Project: **RFQ-1202-2025**
Project Name: University Hall HVAC Upgrade
Project Number: 20020136
Date: August 15, 2025
Page: 1

This addendum forms a part of the RFQ documents and will be incorporated into the Contract Documents, as applicable. This addendum changes and shall govern over the referenced sections of the original RFQ documents or any previously issued addenda. Acknowledge receipt of this addendum on the quotation form. Failure to acknowledge receipt of addenda on the quotation form shall result in disqualification.

PROJECT	McMASTER UNIVERSITY		DRAWING
	HAMILTON, ONTARIO		
263	ADMINISTRATION BLDG.		7.
SECTION D-D, E-E, F-F, G-G.			
DATE	ASSOCIATED ARCHITECTS		MADE BY
6-5-29	W. L. SOMERVILLE, ARCHT. - J. FRANCIS BROWN & SON		E. D.
CHECKED	TWO BLOOR ST. W.		APPROVED
	TORONTO, CANADA		W. L.
			FOR

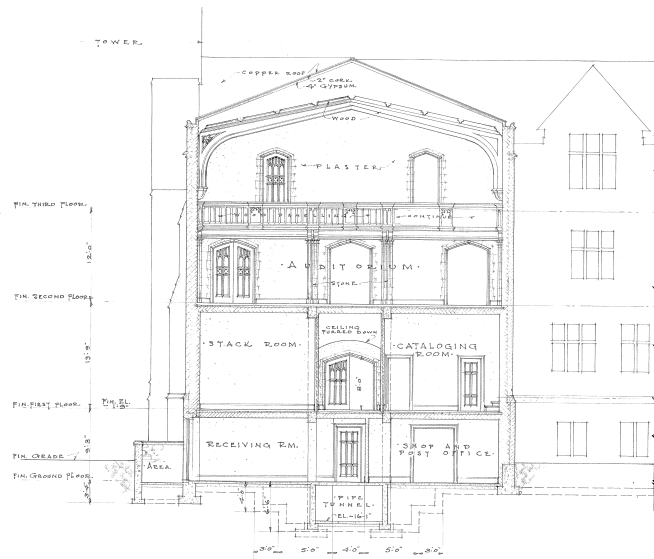
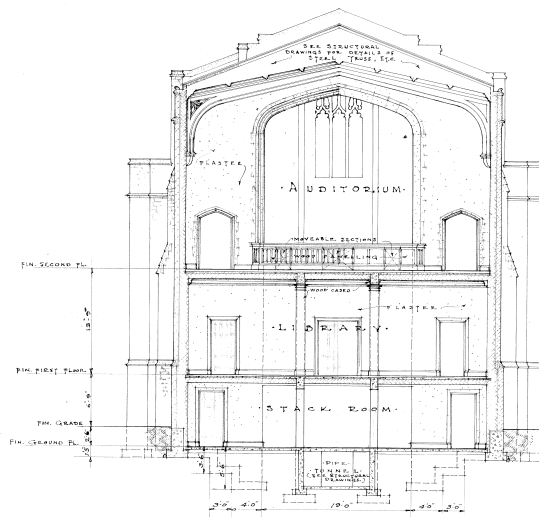
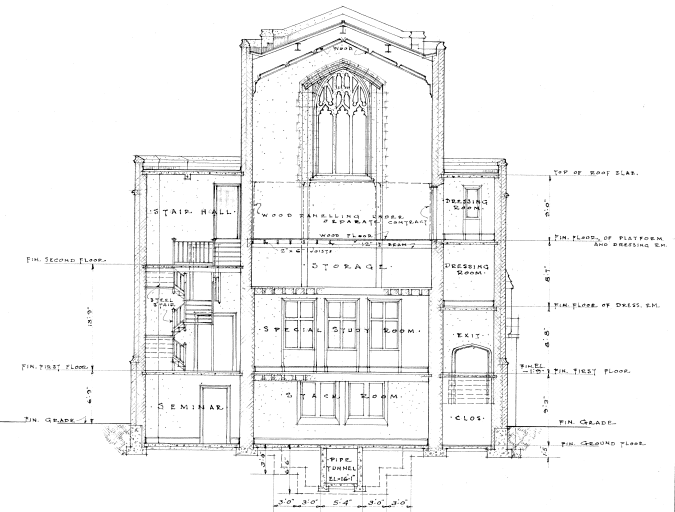
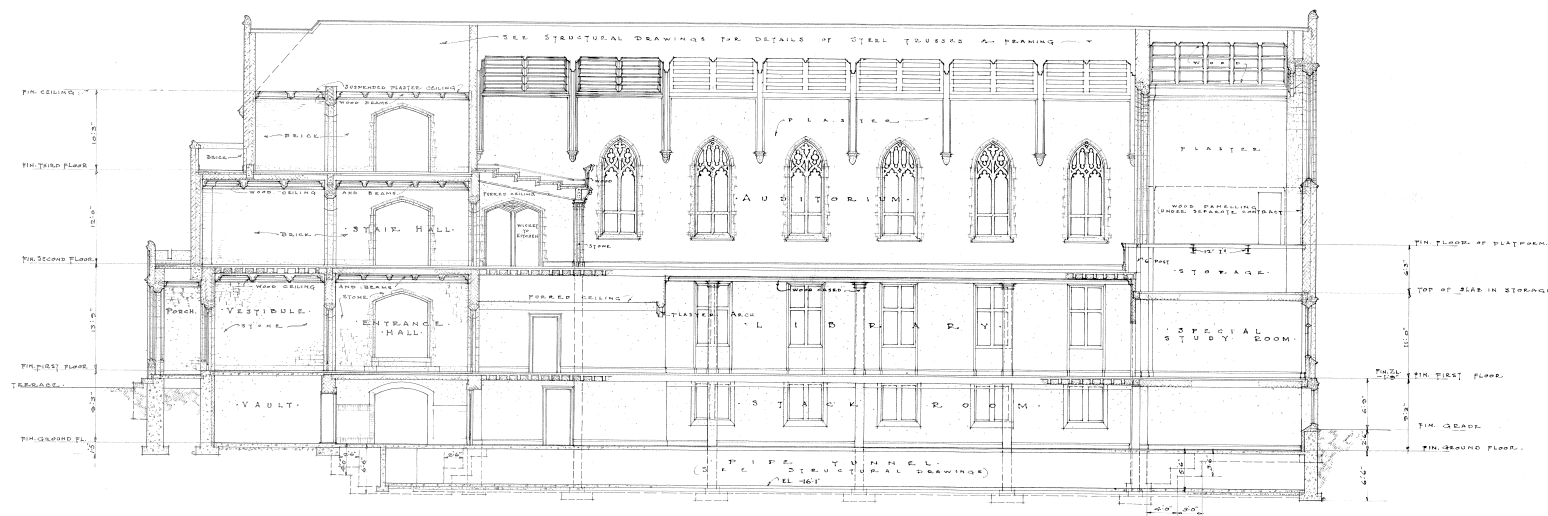
Please advise the ceiling height and structural slab height of each floor.

Refer to enclosed PDFs 01A006 and 01A007 for cross sections of the original building providing floor to floor heights.
